CONSOLIDATED EDISON COMPANY OF NEW YORK, INC.
INDIAN POINT NUCLEAR GENERATING UNIT NO. 2

FOURTH SUPPLEMENT TO:
PRELIMINARY SAFETY ANALYSIS REPORT

INTRODUCTION

FIGURE 2-1

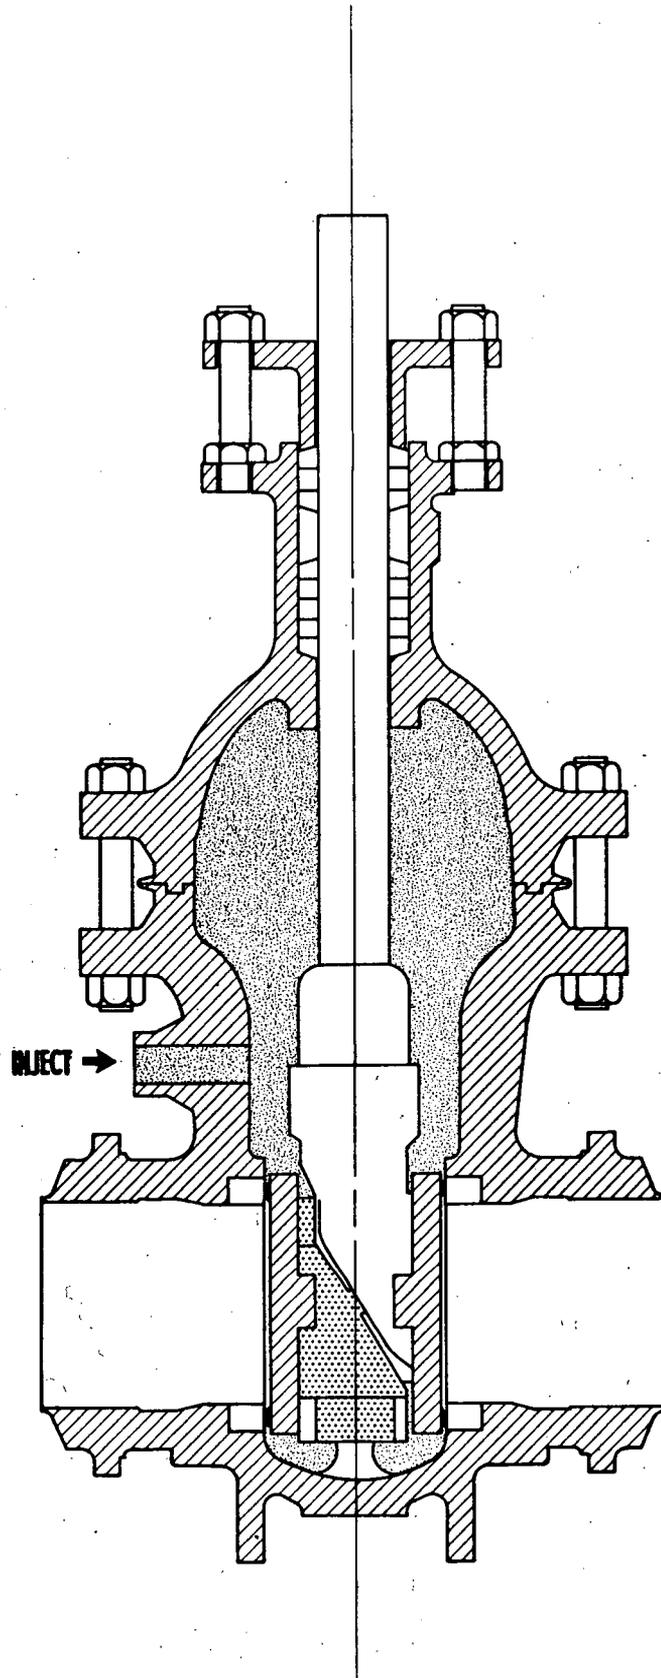
A detailed evaluation of this system has resulted in some modifications to the conceptual design described and illustrated in Chapter 5 of the PSAR. These modifications do not alter the principle of leak prevention described in Chapter 5 of the PSAR, but provide several improvements. The modified system is described in this section. Figure 2-1 shows the revised flow diagram of the system.

SAFETY INJECTION SYSTEM
FIGURE 3-1

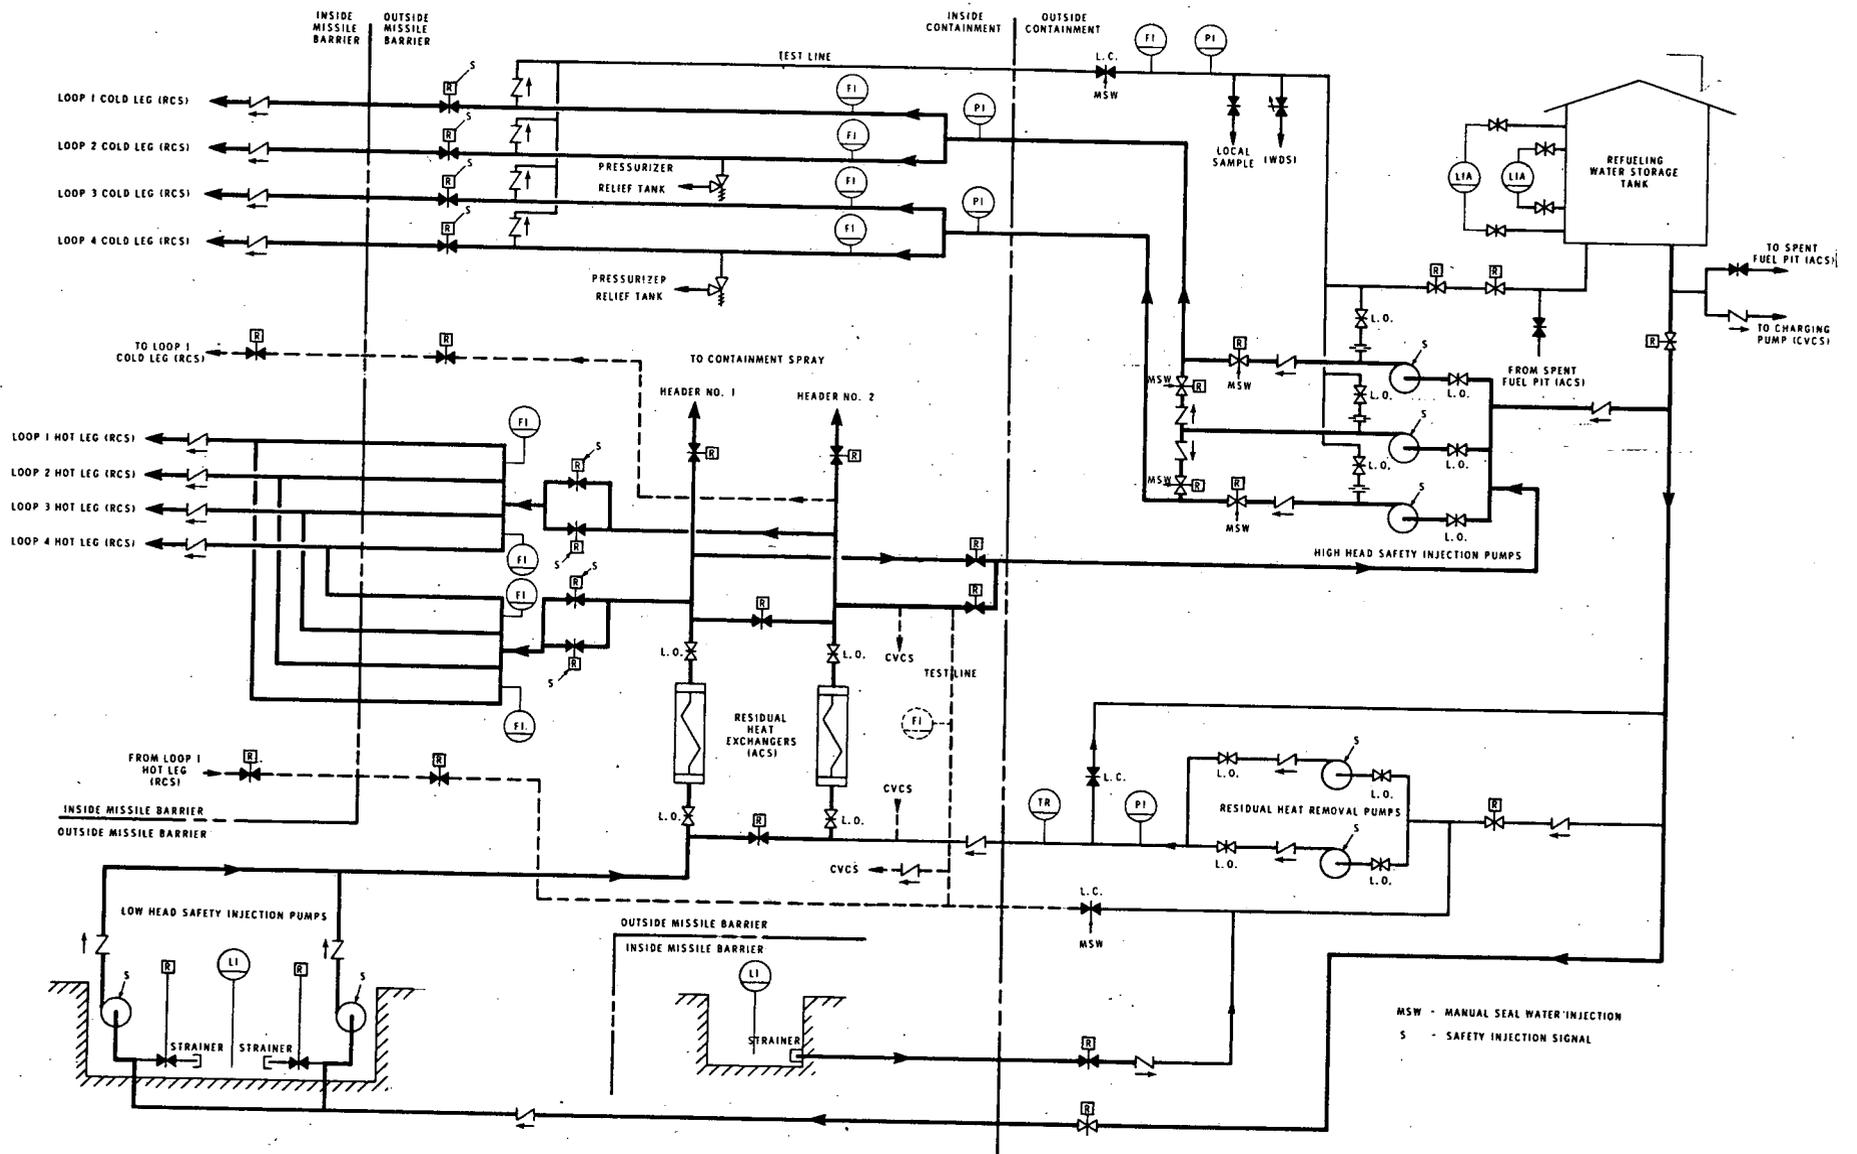
The Safety Injection System for the Indian Point Unit No. 2 (as shown in the process flow diagram, Figure 3-1) is made up of several independent subsystems. These subsystems each contain redundancy of equipment and redundancy of flow paths inside of the missile protection boundary. This redundancy assures complete reliability of operation and assures continued core cooling, even in the event of a credible failure of a component.

The two independent deluge systems are shown on the process flow diagram, Figure 3-1. One system utilizes the two residual heat removal pumps, each of which take suction from a line from the refueling water storage tank. These pumps deliver borated water through the residual heat removal line, one of the two residual heat exchangers, and through an injection header and four injection lines to the connections on the hot-leg piping of each of the four reactor coolant loops.

The safety injection equipment needed during the immediate post-accident injection phase of operation is started automatically upon coincident signals of low reactor coolant pressure and low pressurizer water level from two of three independent pressure and two of three independent level channels. The valves and pumps actuated by the automatic safety injection signal are indicated by the "S" on Figure 3-1.
